**Proposed Residential Development
at
Railpark West
Maynooth
County Kildare**

**Traffic Impact Assessment
including
Quality Audit
Stage 1/2 Road Safety Audit
DMURS Compliance Statement**

This report was prepared in response to a request from Michael Moran, TPS M Moran and Associates, for a DMURS Quality Audit including a Stage 1 Road Safety Audit for a proposed residential scheme known as Railpark Phase 1, in Maynooth, Co. Kildare on behalf of Montane Developments.

Drawing 24-004-P-1.200 Duignan Queen Architects, Railpark street.

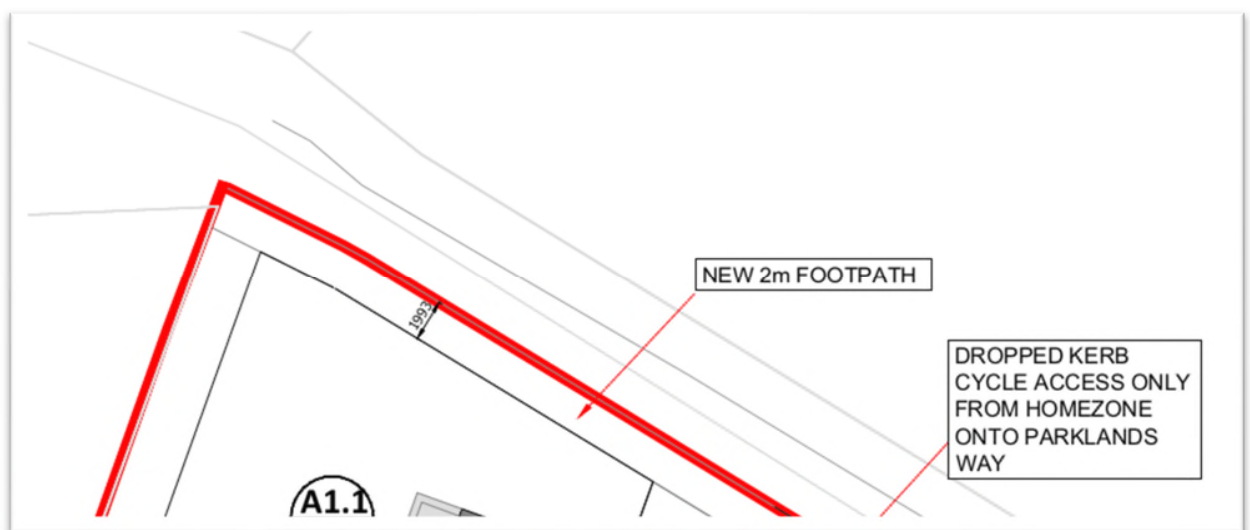
It is proposed to provide a 2m footpath along Railpark for the extent of the site west of the second existing residential unit. There is however a section of Railpark before the Parklands development without a footpath. Pedestrians will have share space with vehicular traffic on this narrow lane which would increase the risk of collisions.

Drawing 25M2-FCE-XX-XX-DR-C-4200 S4 P02, Street Classification.

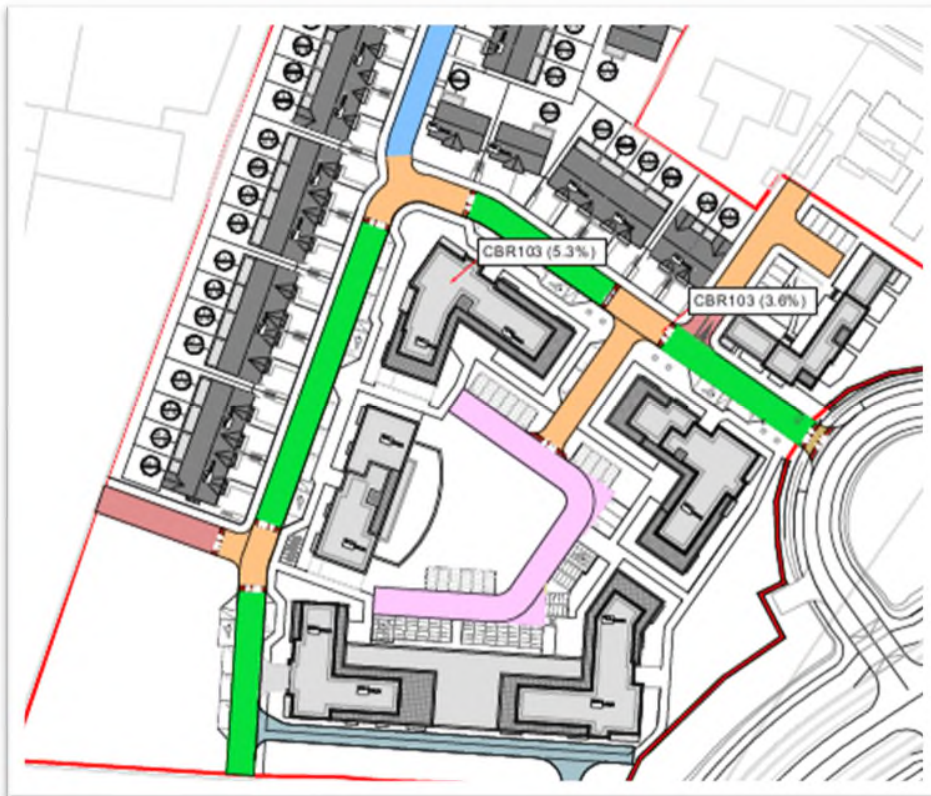
4.3 Problem

Drawing 25M2-FCE-XX-XX-DR-C-1101 S4 P04, uncontrolled pedestrian crossing, Road 1.

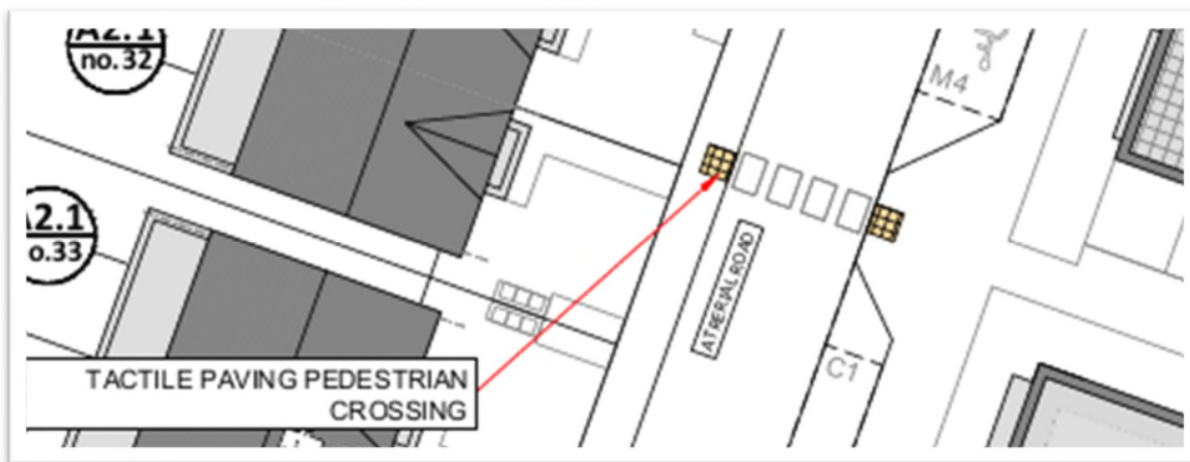
4.4 Problem

Drawing 24-004-P-1.200 Duignan Queen Architects, Site Layout Plan, MERR Cycle Link.

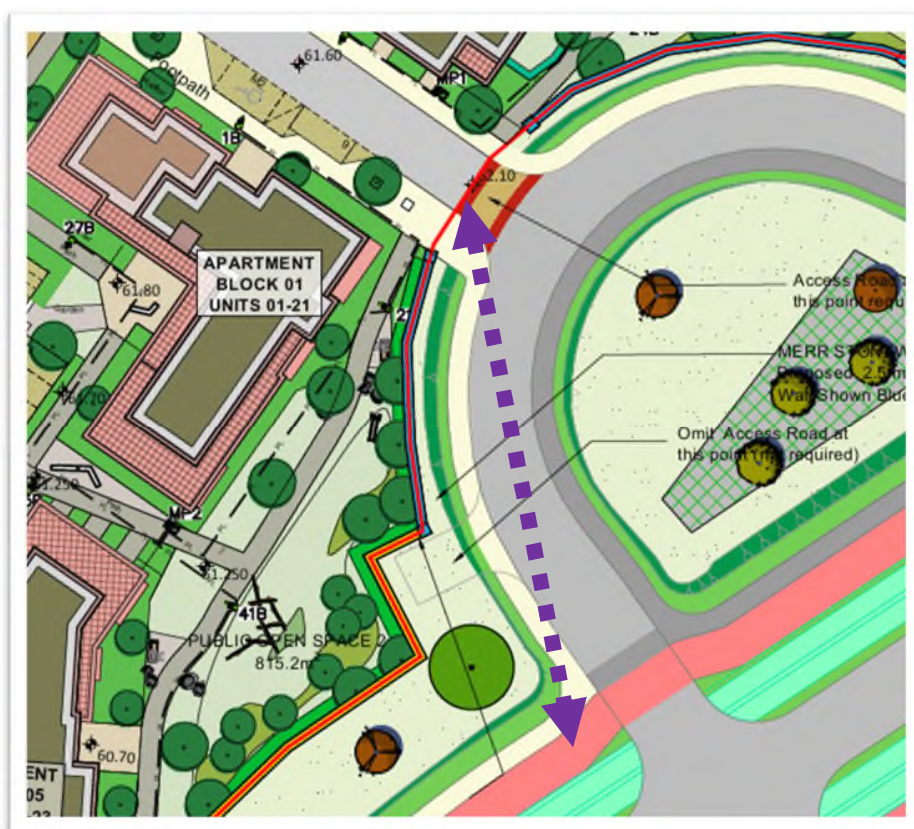
There is no link proposed on the collector road for cyclists to get from the development to the MERR and vice versa. Cyclists would have to share space with vehicular traffic.

Drawing 24-004-P-1.200 Duignan Queen Architects, Bike storage.

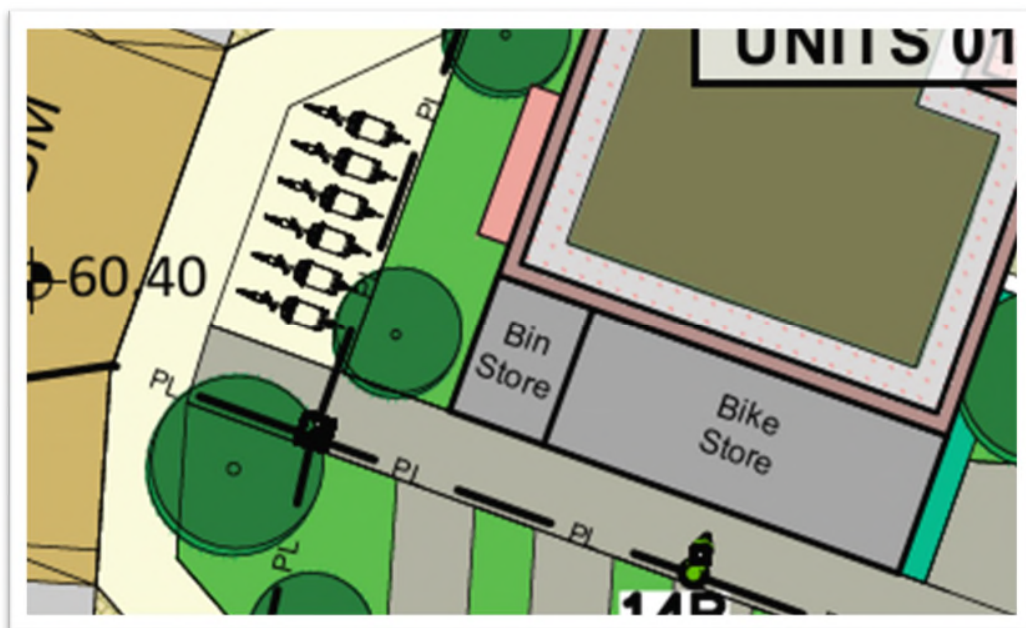
It is unclear if any bicycle storage is being provided for cargo bikes. Cargo bikes take additional room to store and the proposed outdoor spaces would not be suitable for longer term parking and could lead to an unnecessary increase in car journeys.
